**First Revision No. 1-NFPA 1917-2013 [Global Input]**

Global change: Where in the document the word “oxygen” is used, replace with “medical gas”.

Figure 6.21.3.3.1 Dimension Lines for Measuring Seat Belt Effective Length.

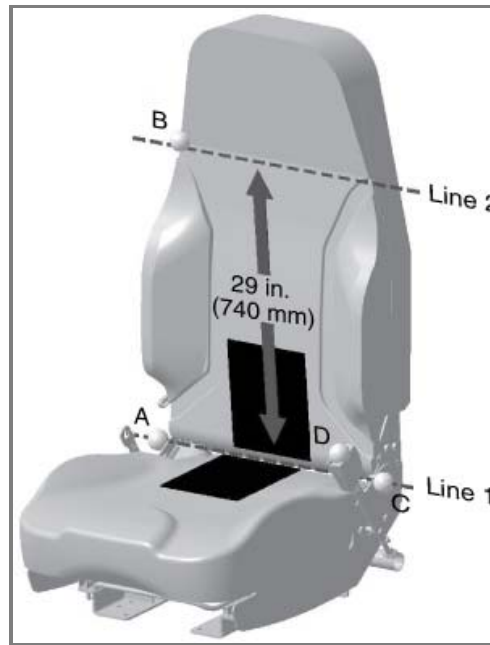
The effective seat belt web length for a Type 1 lap belt for pelvic restraint shall be a minimum of 60 in. (1524 mm) with the seat adjusted all the way back and down when measured using the following procedure and referring to Figure 6.21.3.3.1 ~~Figure 6-21-3-2-1~~ :

- (1) Locate an imaginary line where the plane of the center of the seat back surface intersects the plane of the center of the seat cushion surface (see line 1 in [Figure 6.21.3.3.1](#) ~~Figure 6.21.3.2.1~~).

- (2) Locate an imaginary line parallel with line 1 and lying on the center of the seat back surface 29 in. (740 mm) from line 1 (see line 2 in [Figure 6.21.3.3.1](#) ~~Figure 6.21.3.2.1~~).

Figure 7.9.3.2 Warning Zones for Optical Warning Devices.

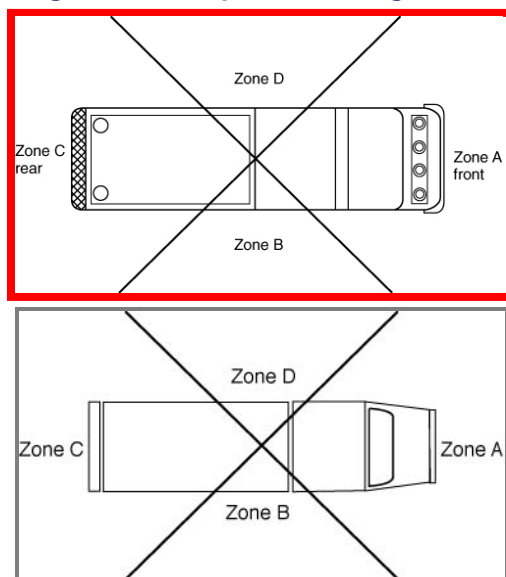
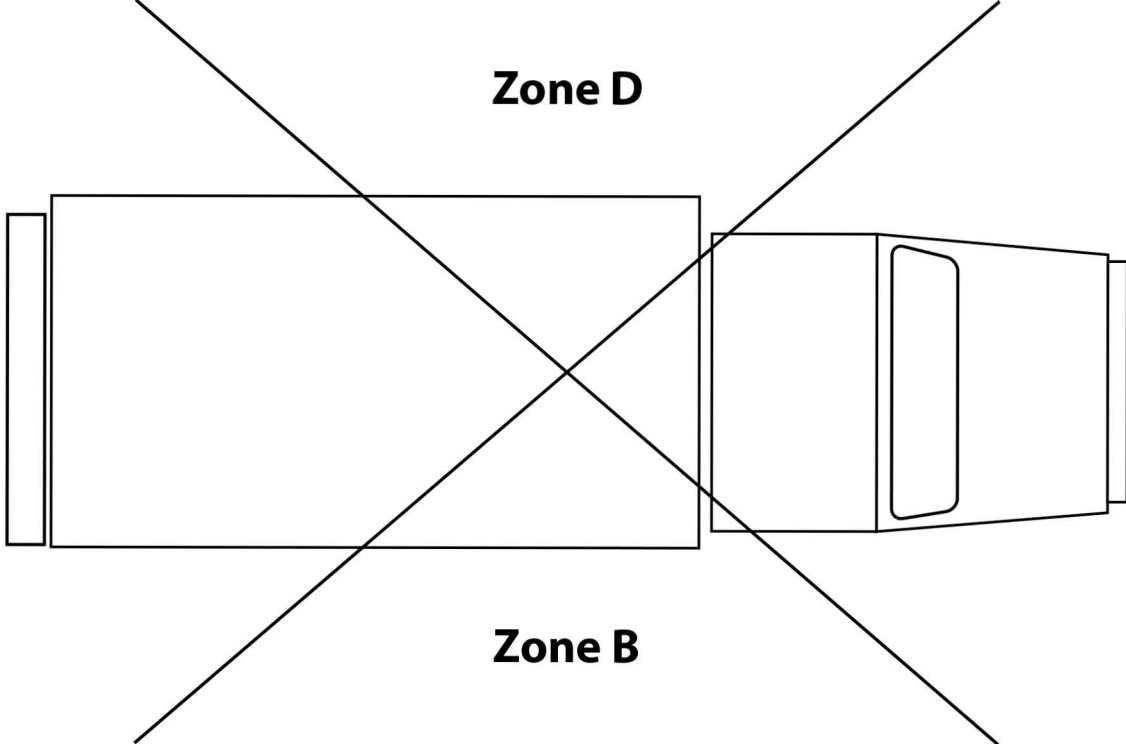
The committee is deleting the existing figure and replacing with the attached figure, which is that of an ambulance.
